## RESPONSE TO REQUEST FOR ADDITIONAL INFORMATION

### APR1400 Design Certification

RAI No.: 16-7915

SRP Section: 08.01 – Electrical Power – Introduction

Figure 2.6.1-1 AC Electrical Power Distribution System

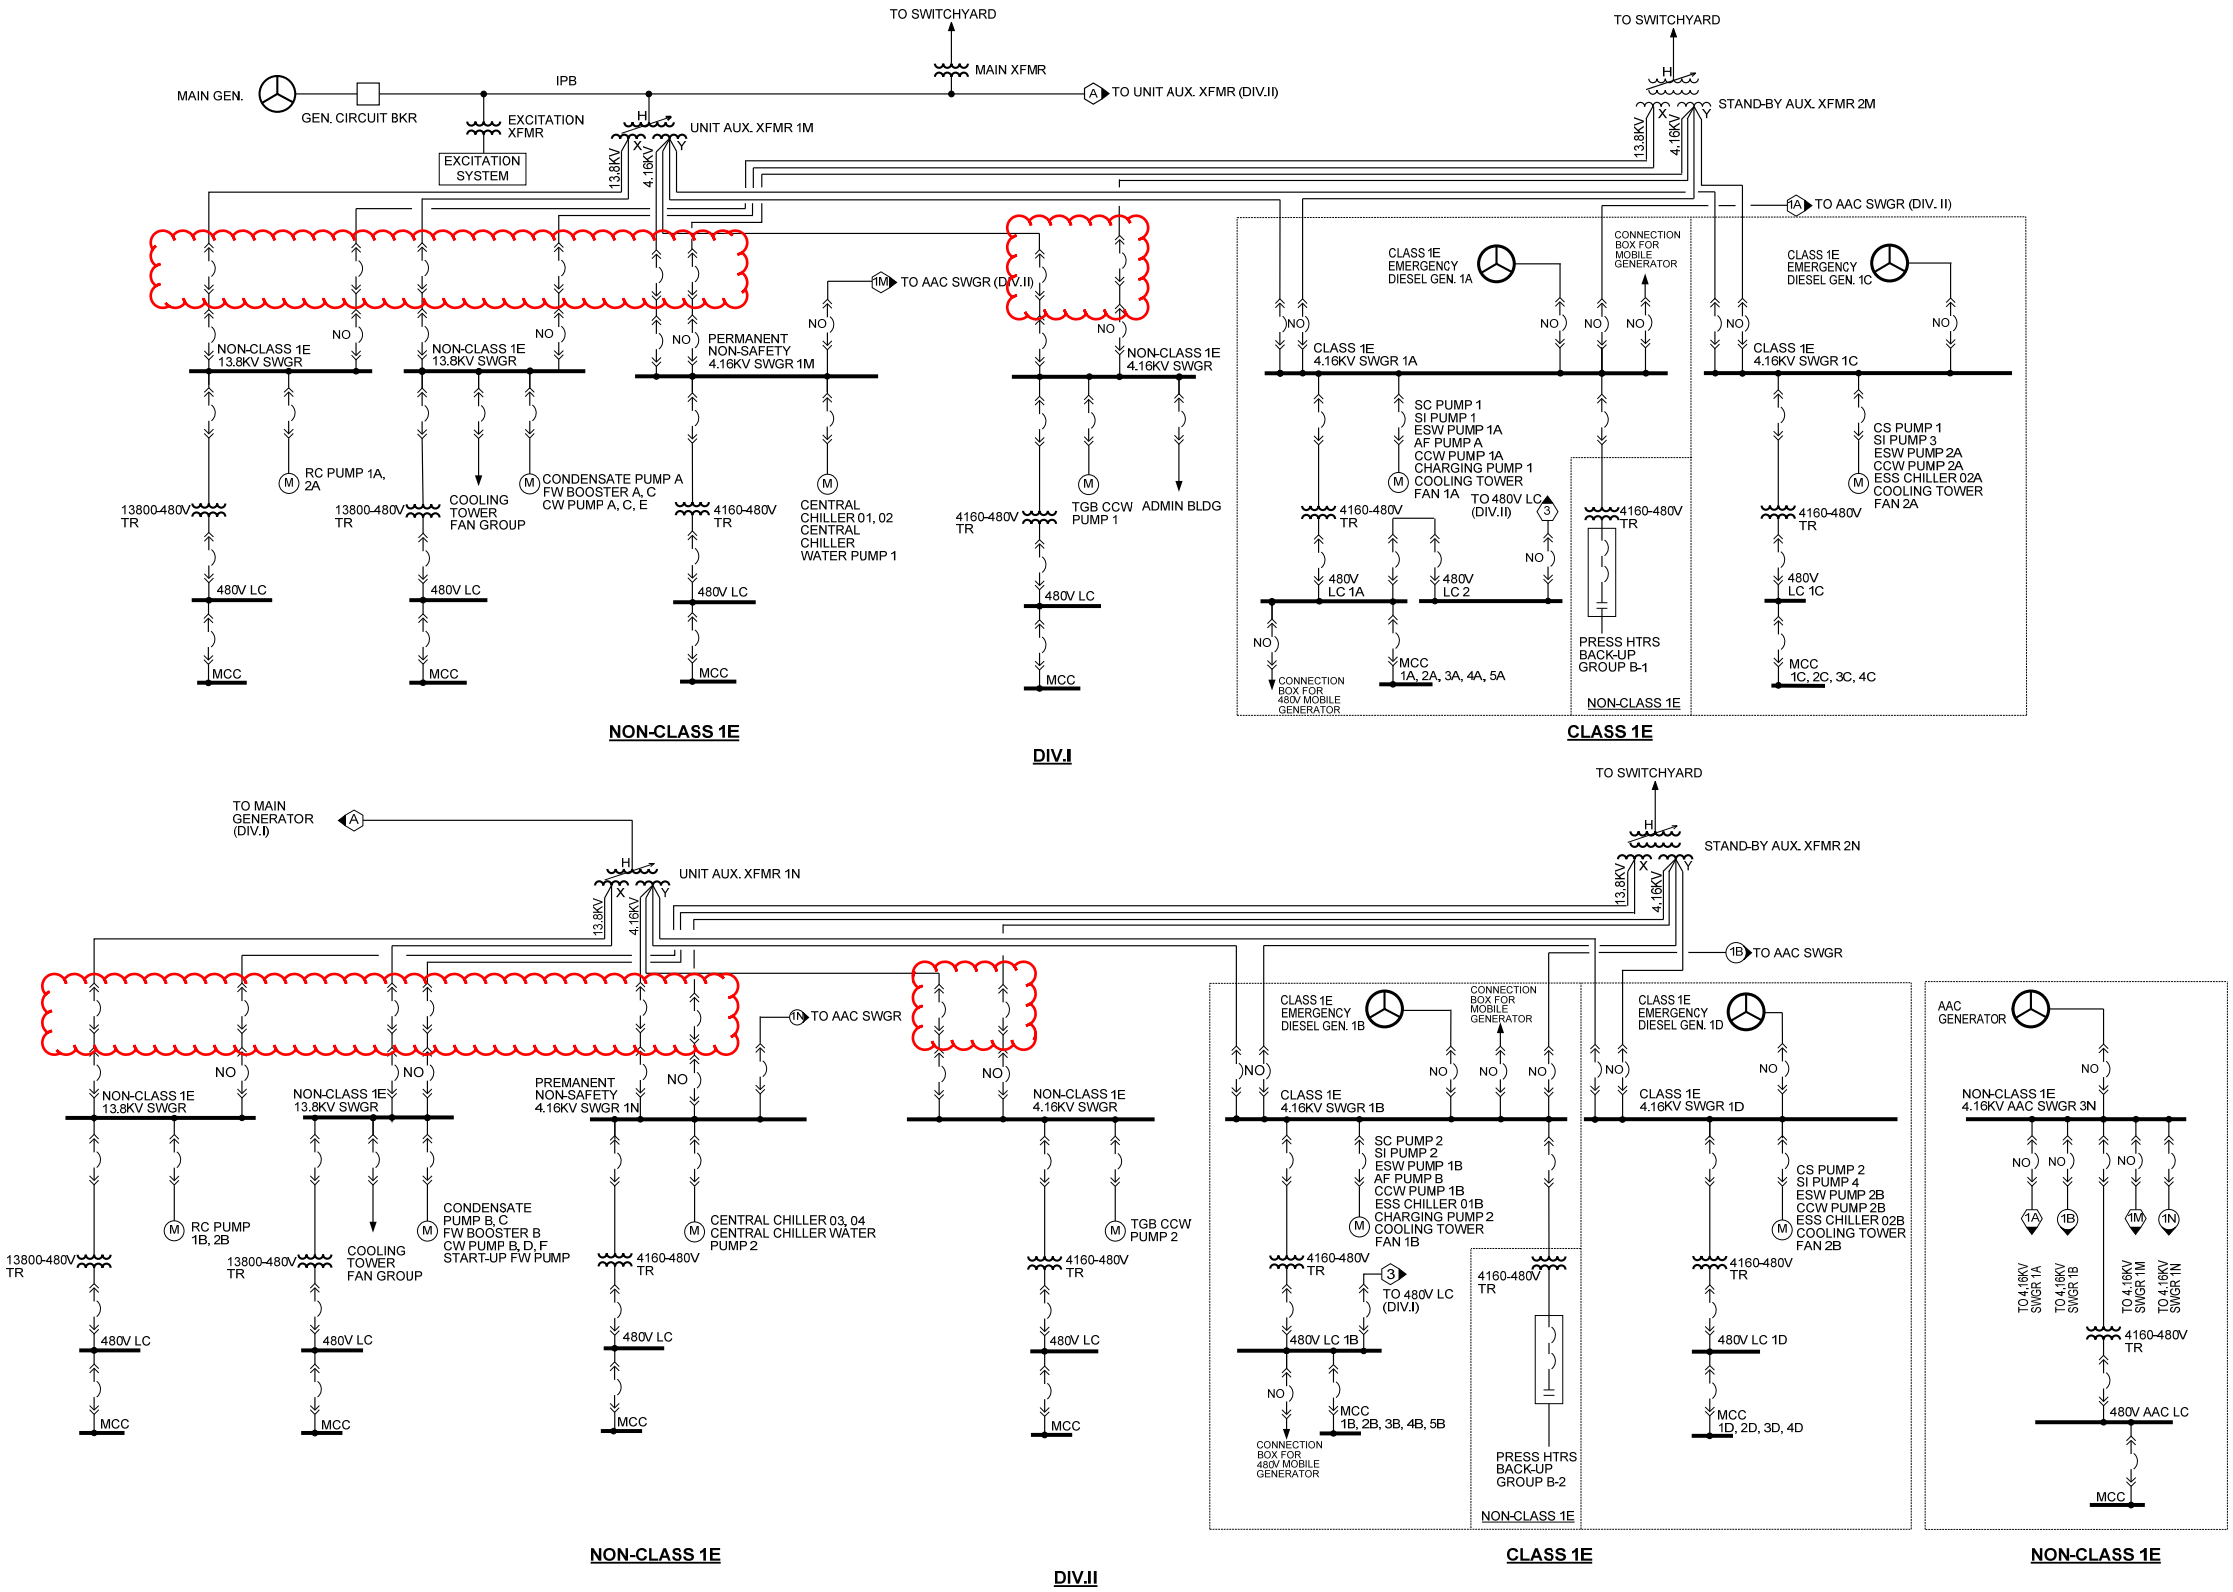
DCD Tier 1 Figure 2.6-1 and relevant sections of Tier 2 Chapter 8 will be revised as shown in the attachment.
